# Public Exhibition Submission to the Ballarat North PSP

64 Sims Road & 134  
Gillies Road, Mt  
Rowan

Ballarat Grammar Foundation

20/10/2025

Figure 2: Extract from Plan 6 Water of the BNPSP

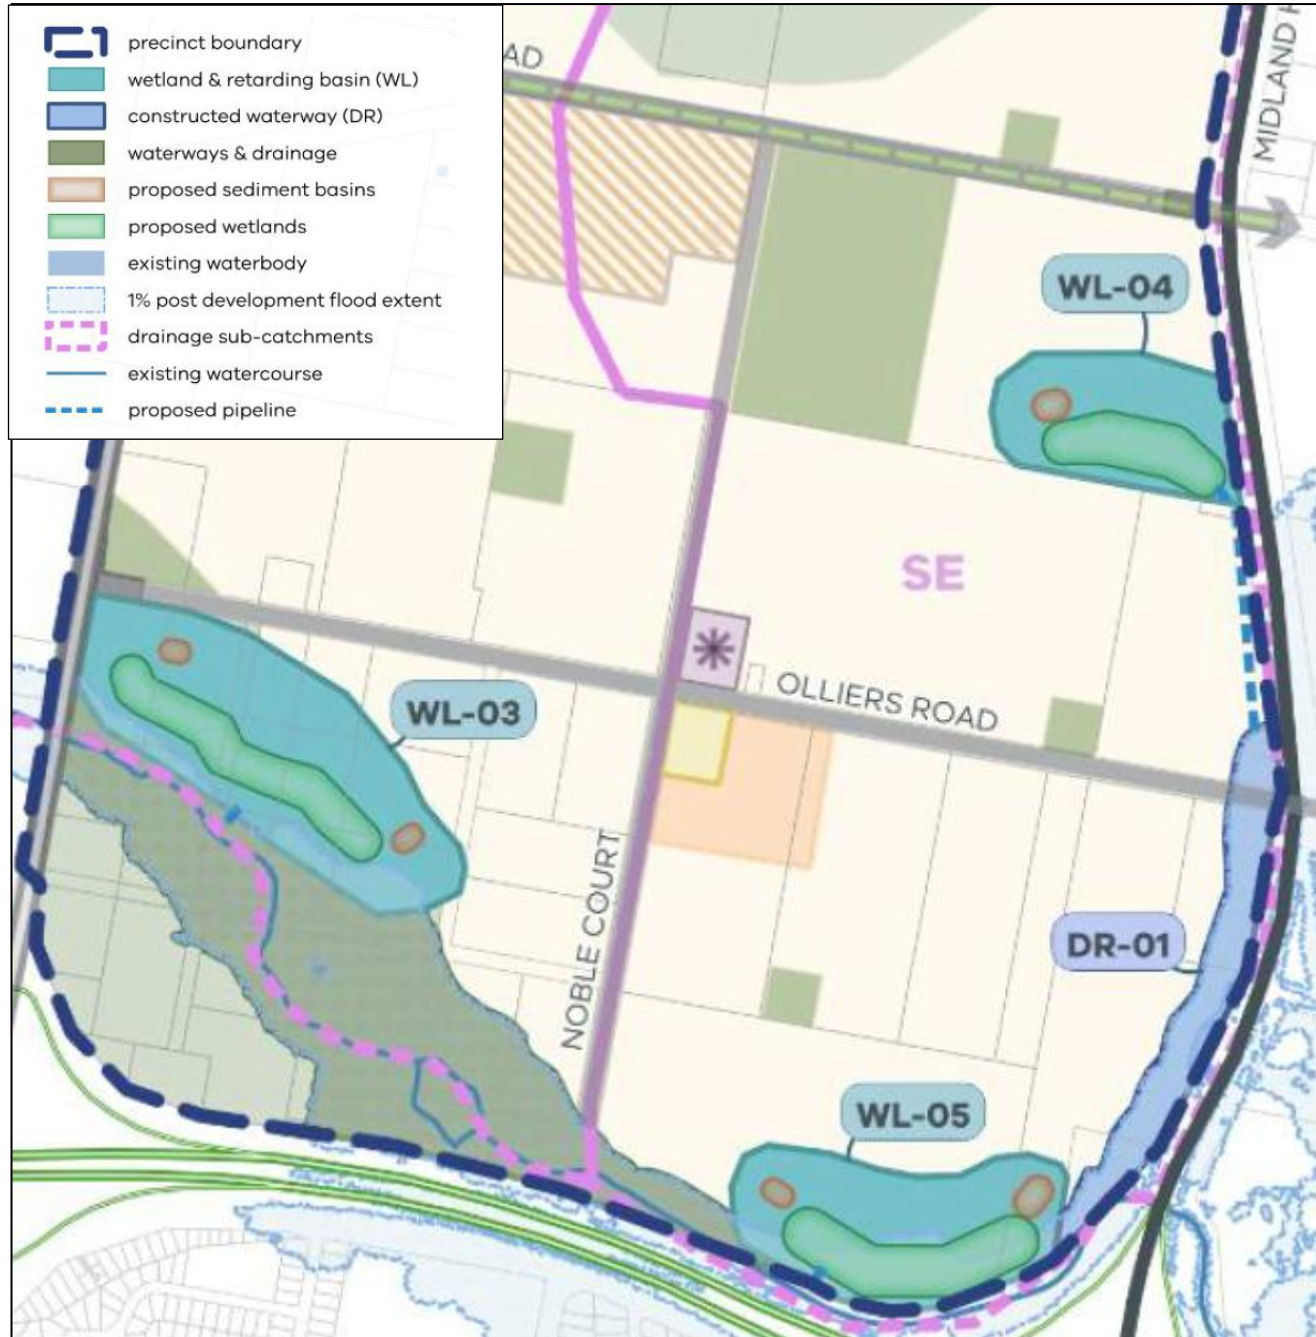
Figure 2 is an extract from Plan 6 Water of the BNPSP showing the proposed location of a wetlands and retarding basins and waterways. The retarding basin on BGF land is identified as "WL-04".

Beveridge Williams, on behalf of Ballarat Grammar Foundation, has reviewed the Ballarat North PSP Drainage Strategy prepared by SMEC (July 2025). While recognising the detailed work undertaken, our review identifies fundamental flaws that will lead to oversized, costly, and poorly located infrastructure with limited benefit to the catchment. The adoption of an implausible worst-case climate change scenario has artificially doubled predicted flows, resulting in basins and wetlands that are unnecessarily large, consume far more land than required, and impose inflated development and maintenance costs that ultimately burden the community through higher housing and infrastructure

charges. These assets are being designed to manage both development impacts and climate change simultaneously, far exceeding what is necessary or appropriate.

The detrimental impacts from locating WL-04 as proposed in the public exhibition version of the BNPSP can be resolved by positioning WL-04 within the flatter land adjacent to the realigned waterway near Olliers Road (refer Figure 3). This location not only reflects best practice but also reduces cost, integrates with existing drainage patterns, removes the requirement for an access track between the basin and Olliers Road and avoids the encumbrance of unconstrained developable land.

Figure 6: Extract from Plan 11 Environmental Constraints of the BNPS

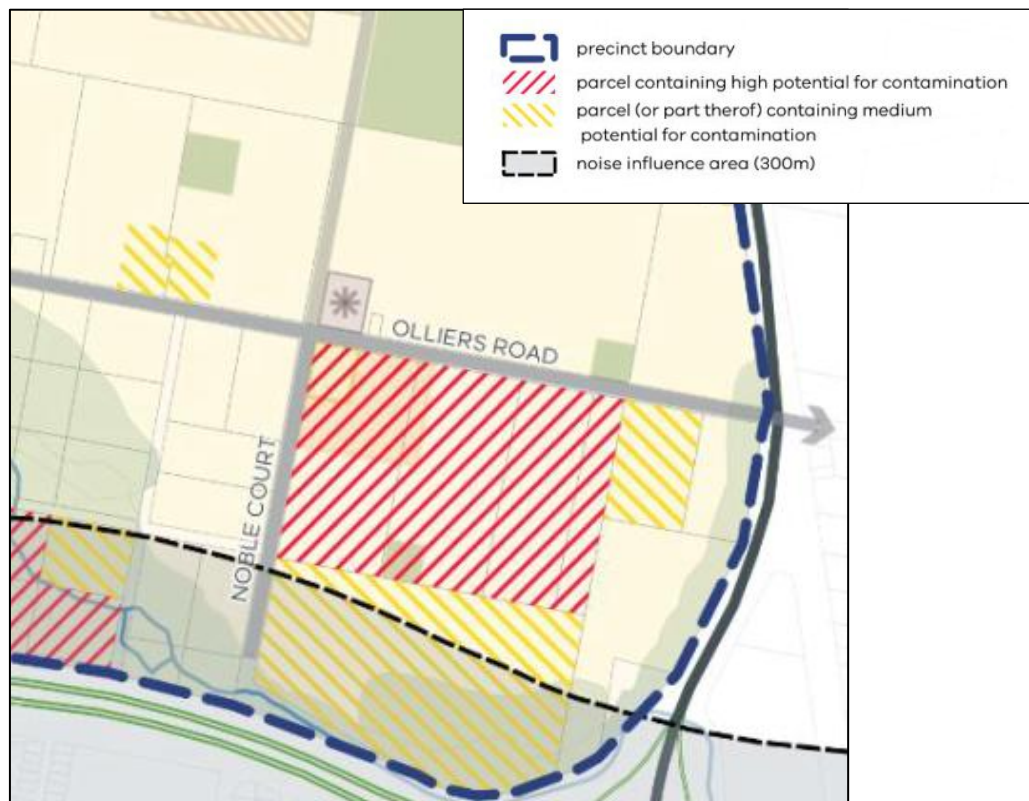
Figure 6 is an extract from the Public Exhibition PSP Plan 11 Environmental Constraints. This shows the PSP the entire area of the proposed primary school and community facility is on land containing high potential for contamination. Conversely, the Beveridge Williams proposed location for the primary school and community is predominately on land not indicated as having any risk of land contamination and with only a limited area of land that has a medium potential for contamination.

The reduction in risk and costs through minimising interaction with land with a high potential for contamination creates an improved community outcome generated by relocating the primary school and community facility.

Figure 7: Extract from Plan 5 Public Realm of the BNPSP

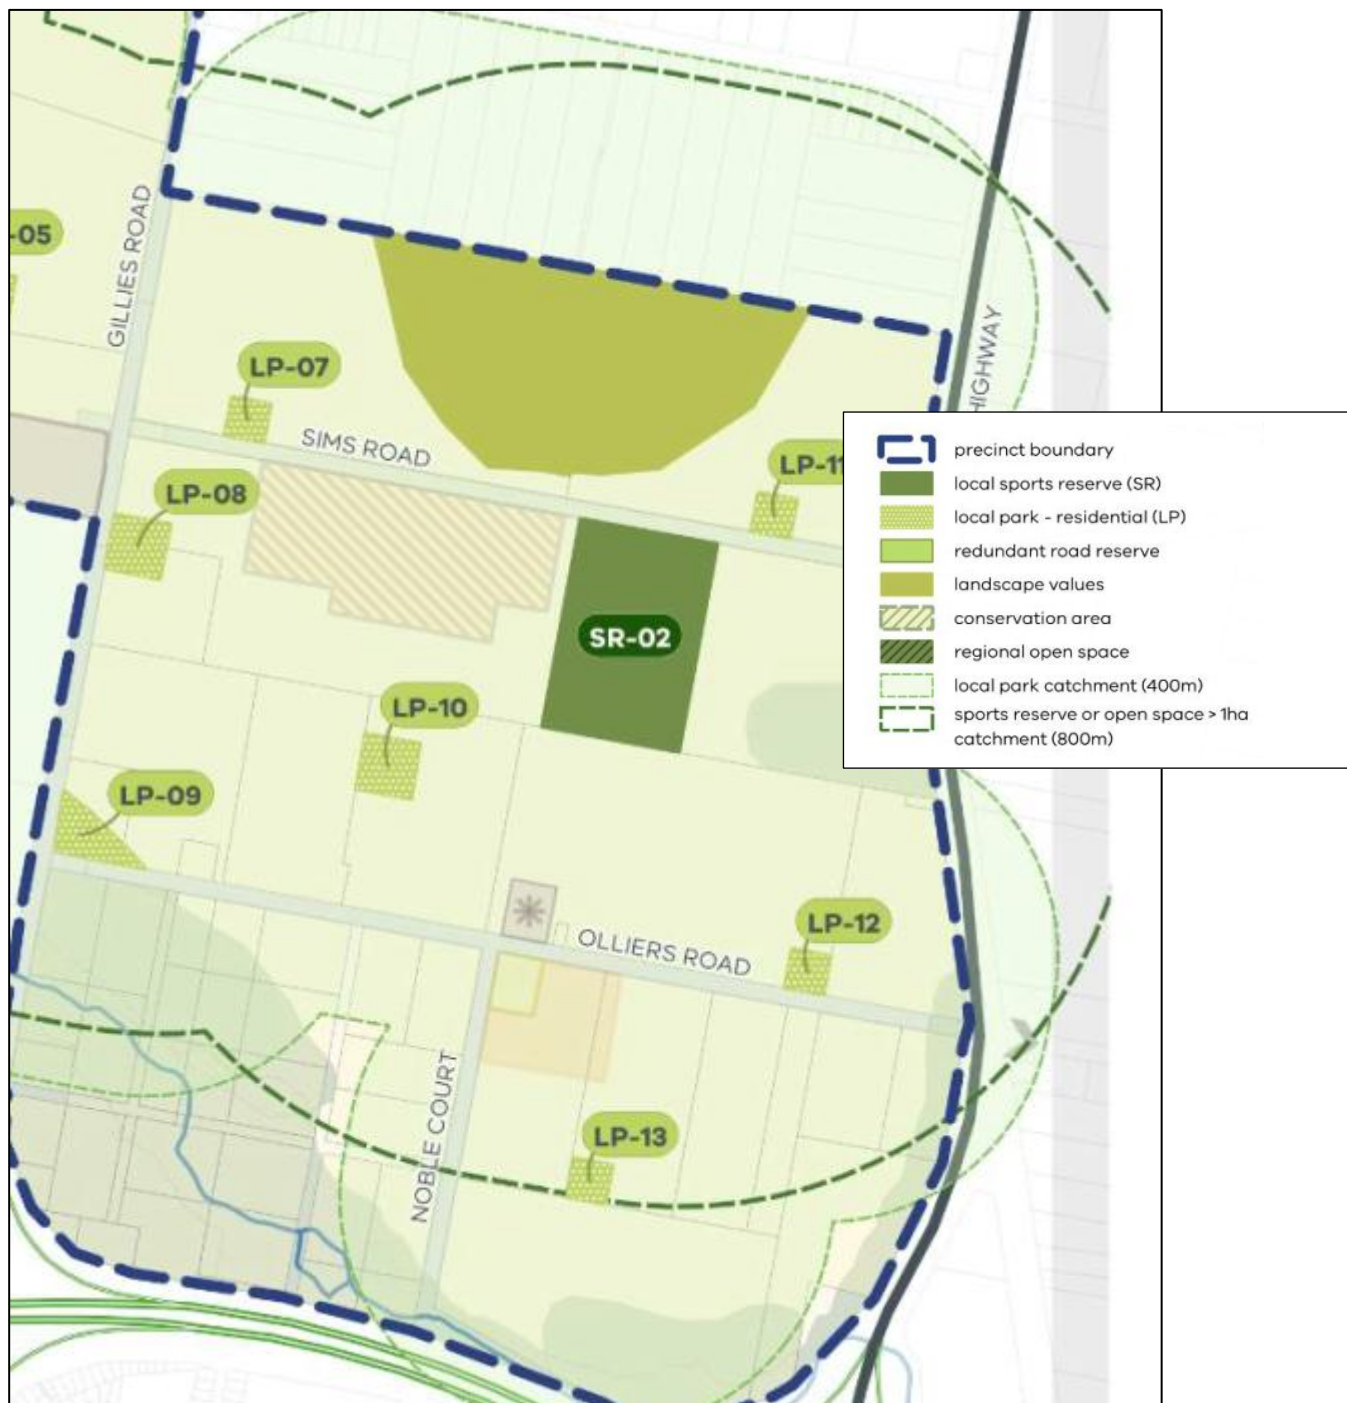
Figure 7 is an extract from Plan 5 Public Realm of the BNPSP showing the proposed location of a 9.26 ha area of public active open space (identified by "SR-02").

We contend this is not the most suitable location for the active open space and that relocation provides improvements for this entire section of the core PSP area and facilities associated place-based plan improvements.

The Beveridge Williams and XYST proposed location of the primary school and community facility on the north-west side of the Olliers Road and Nobel Court road extension (see Section 4.2) provides a new opportunity for the SR-02 active open space to be collocated with the primary school, refer to Figure 8.

Figure 9: Comparison of Active Open Space Catchments

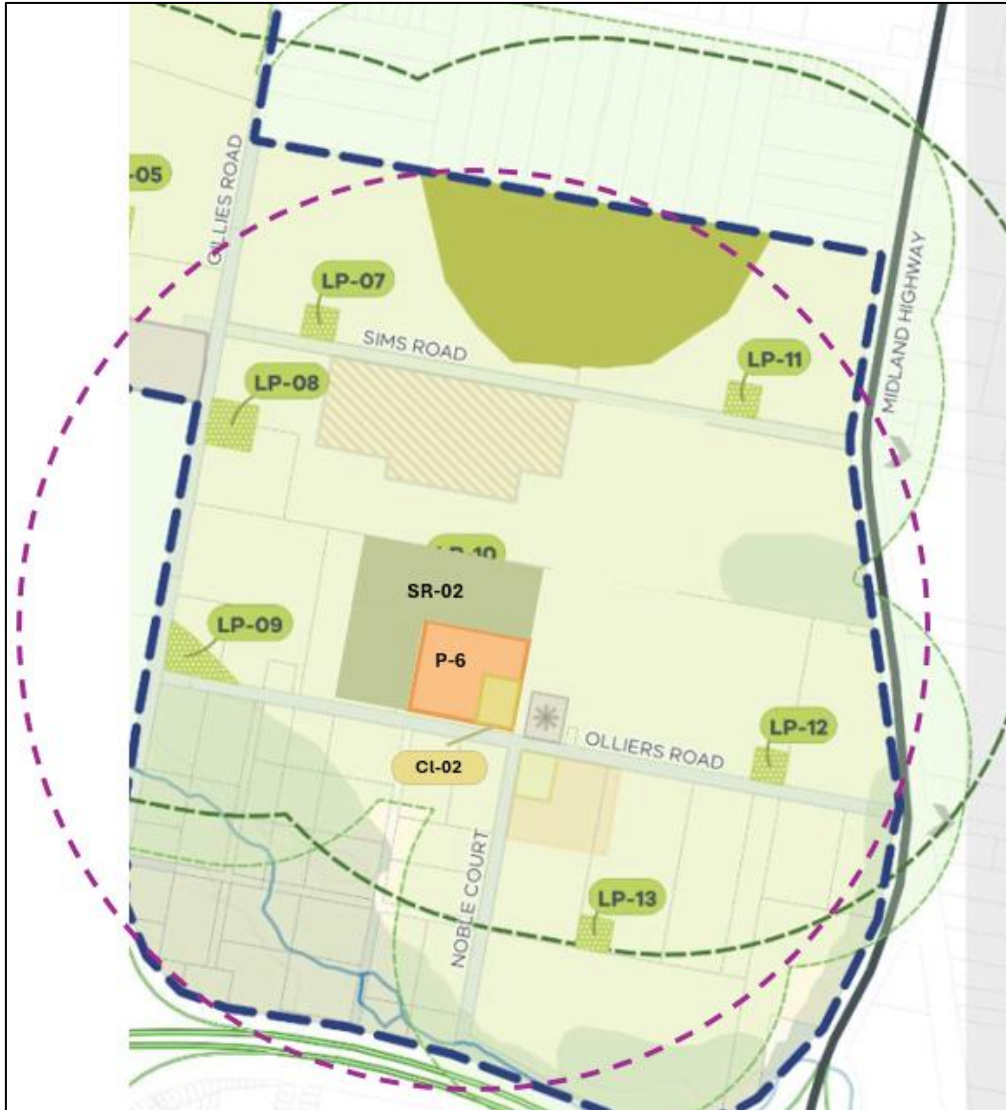
In Figure 9 the dark green dashed line shows the catchment for the Public Exhibition PSP location of SR-02. The dashed purple line shows the catchment for the Beveridge Williams proposed location of SR-02. It is evident that Beveridge Williams location results in more of the PSP area being within the catchment which is an improved outcome for future residents.

Figure 10: Comparison of Topography & Slope for Active Open Space Locations

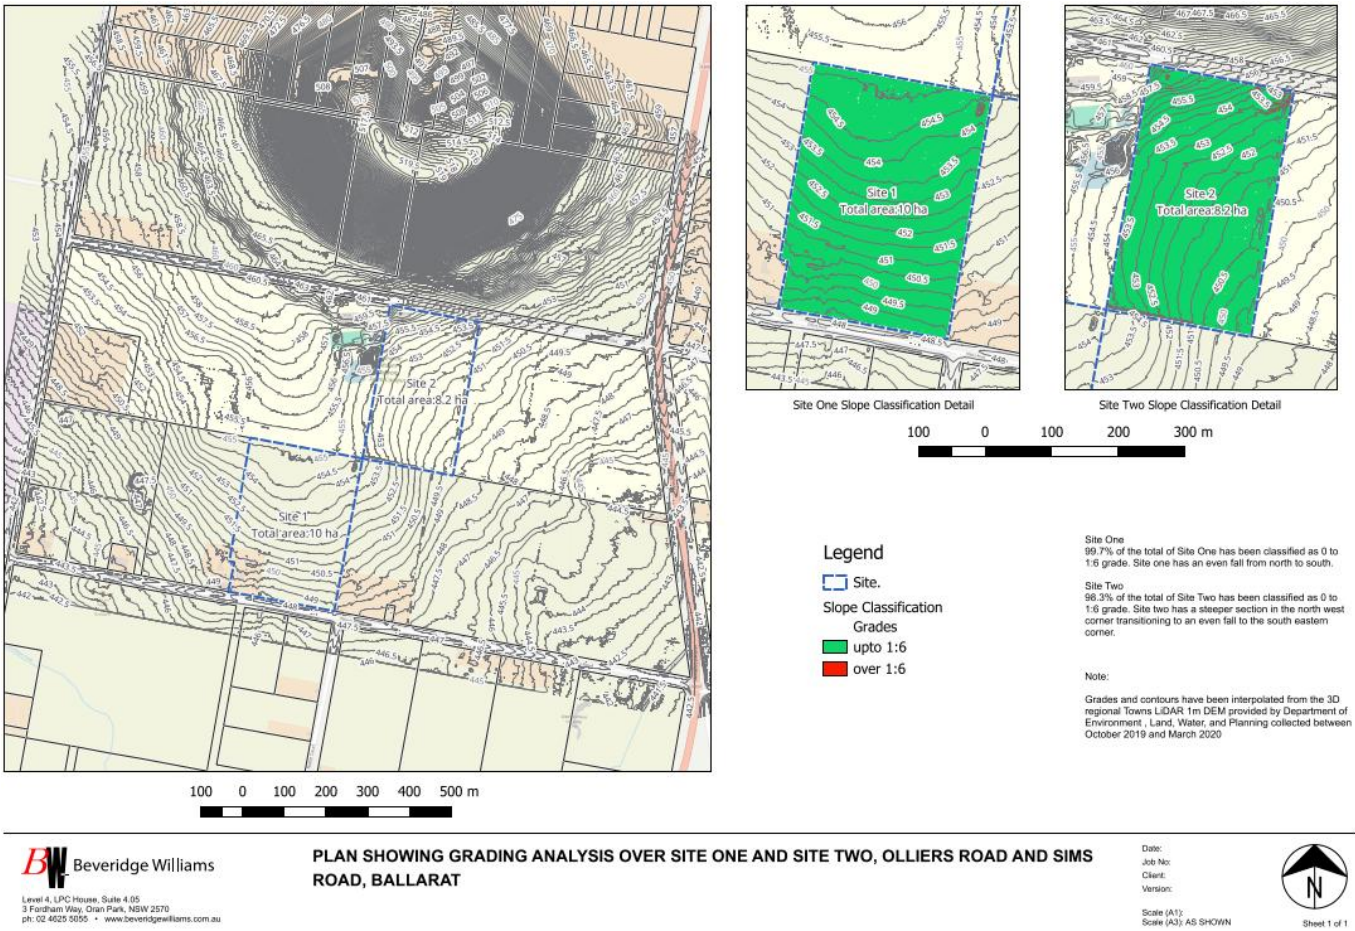
Requirement R29 of the PSP identifies that land for a sports reserve (i.e. SR-02) must have a maximum gradient of 1:6. Figure 10 shows that both the PSP (Site Two) and Beveridge Williams (Site One) proposed locations for SR-02 have a slope of less than 1:6. However, it is noted that contours show that the Beveridge Williams location has a land fall of approximately 6m whereas the PSP location has an approximate fall of 8m.

The use of the Beveridge Williams location for SR-02 is considered to reduce DCP costs as engineering works to prepare the land for the sports reserve will be reduced.

Figure 2: Draft North Ballarat PSP Place Based Plan following co-design workshop (October 2024)

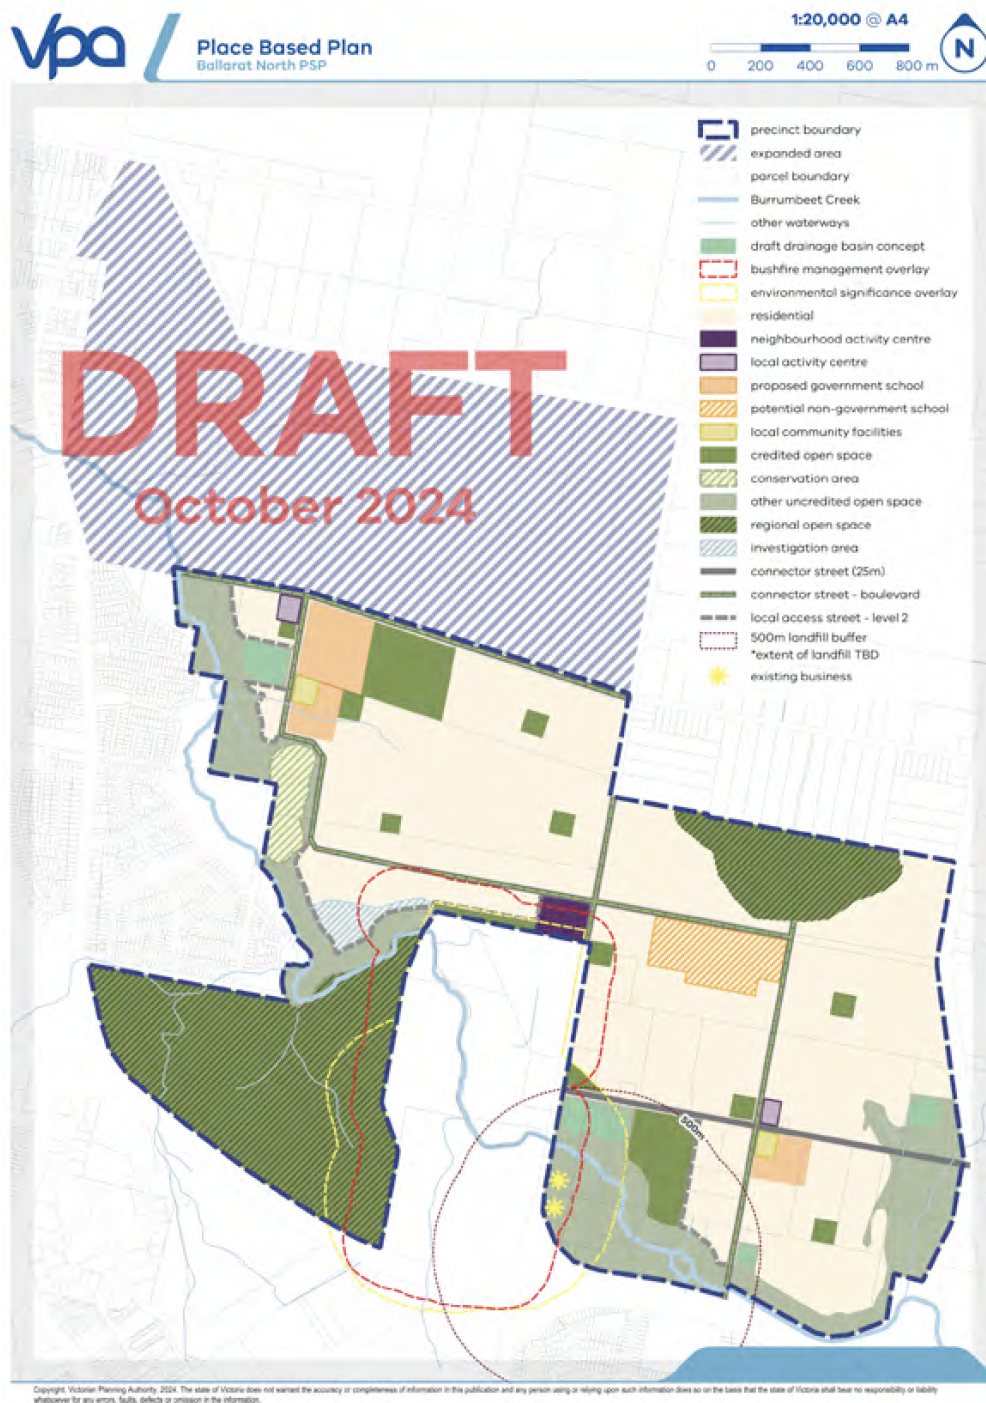
BGF participated in consultation on the Ballarat North PSP, including attending a co-design workshop. The outcome of the co-design workshop resulted in a draft Place Based Plan (October 2024) which located the active open space near Burrumbeet Creek.

The Place Based Plan also located a boulevard connector street through the BGF land and a local open space in part of the land owned by the school. This Draft Plan was acceptable to BGF.

Figure 3: Current Ballarat North PSP Place Based Plan

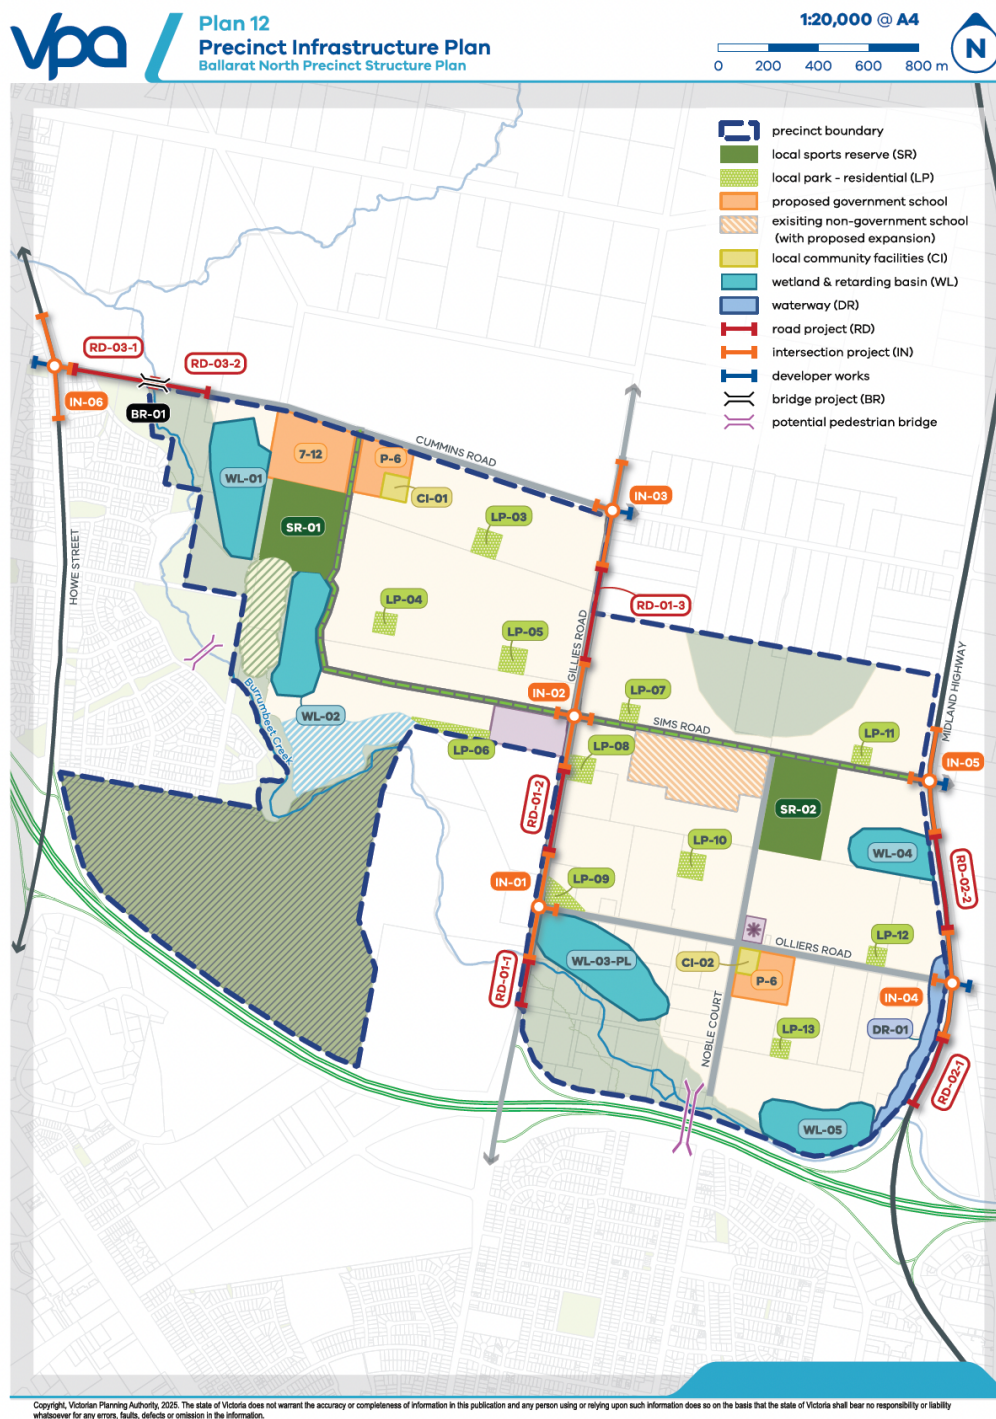
The Plan proposed in the Ballarat North PSP has changed the location of the sports reserve to be located on a significant portion of the BGF land (9.26ha), labelled in Figure 3 as SR-02. It now also includes a large water drainage pond, further reducing the size of the school land (WL-04).

This new plan is not acceptable to BGF, and alternative locations appear to be available without taking this large amount of BGF land to develop into sports reserve.
